# Application for "Other Business" Cobb County, Georgia

Location: Southeast side of Cobb Place Boulevard, Southeast of Vaughn Road  
(street address, if applicable; nearest intersection, etc.)

State specifically the need or reason(s) for Other Business: Request modification to Z-17 of 2011 to delete the commercial indoor recreation usage with outside tennis courts, corresponding with Town Center Design Guidelines, and allow for office and warehouse use, corresponding to LI Zoning District Guidelines.

PETITION NO. Z-017

Proposed

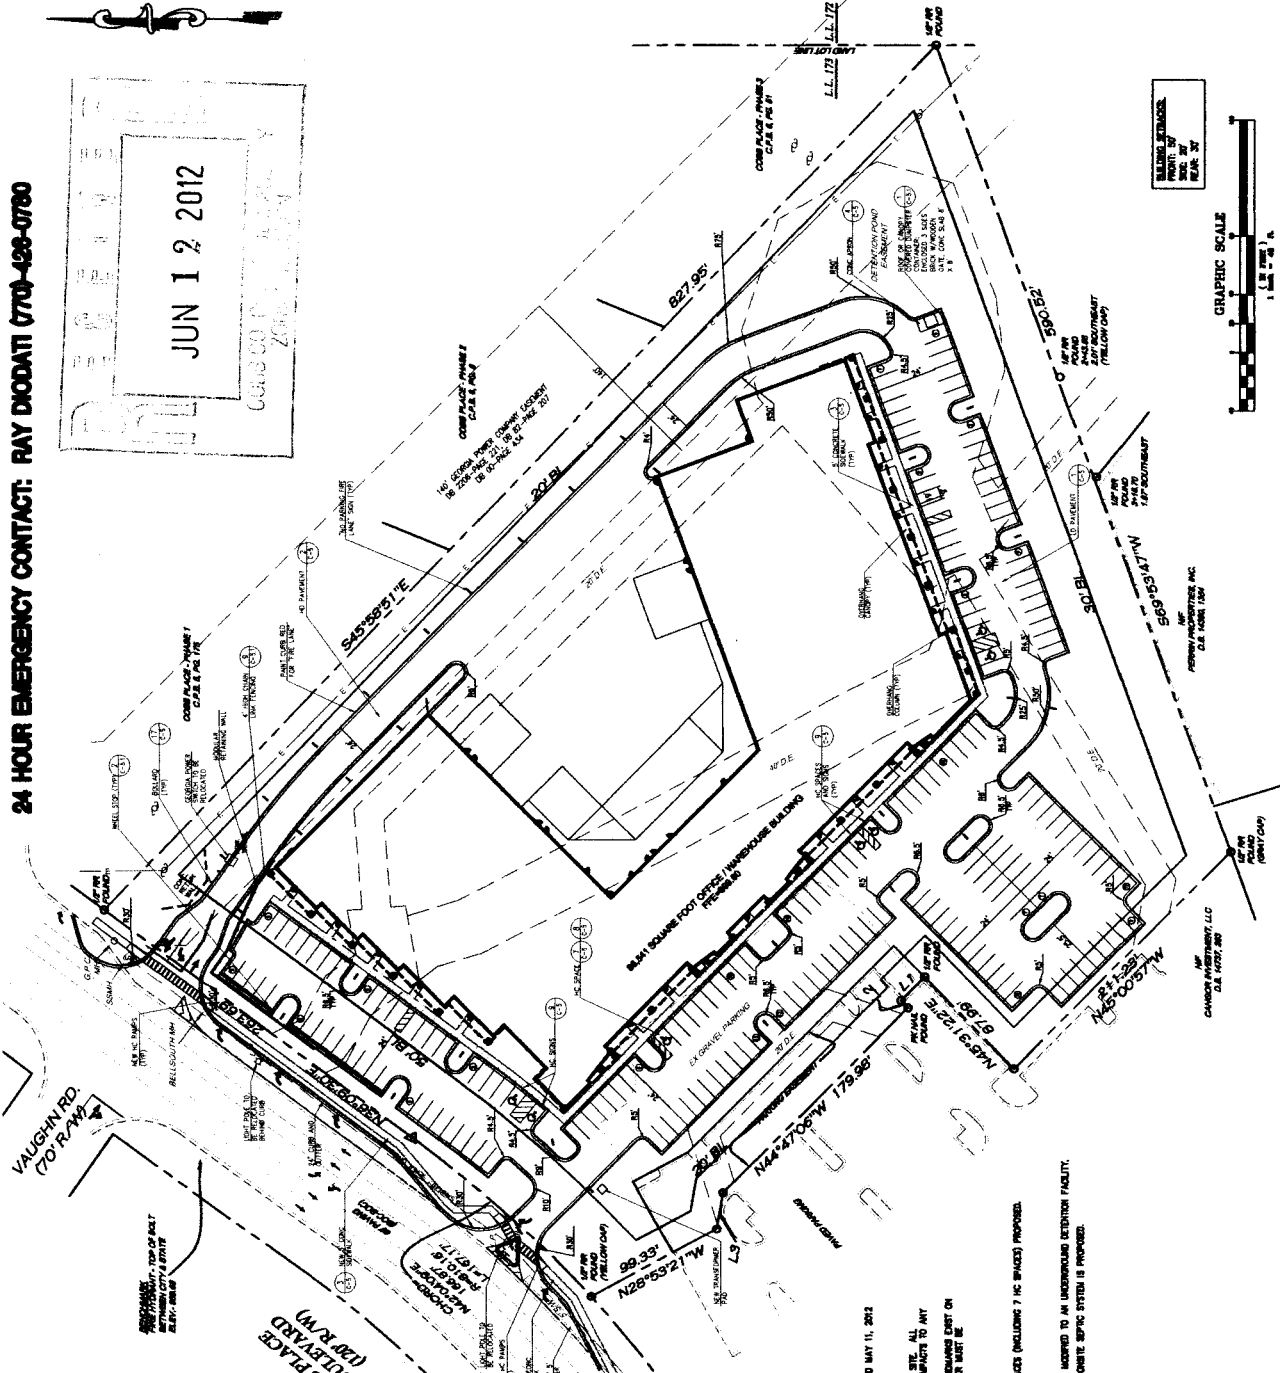
- No Stormwater controls shown \_\_\_\_\_
- Copy of survey is not current – Additional comments may be forthcoming when current site conditions are exposed.
- No site improvements showing on exhibit.

1. The site is encumbered by an existing detention pond as well as previously recorded multiple drainage easements. The current above-ground pond will be replaced by an underground facility. The new detention facility must account for the existing development on Tract 1, the proposed tennis center development on Tract 2 as well provide conveyance capacity for the upstream runoff through the site.
2. Any changes to the existing drainage easements must be reflected on a re-recorded plat.

Recommend applicant relocate the proposed driveway and coordinate with Cobb County DOT on the location at the time of plan review.
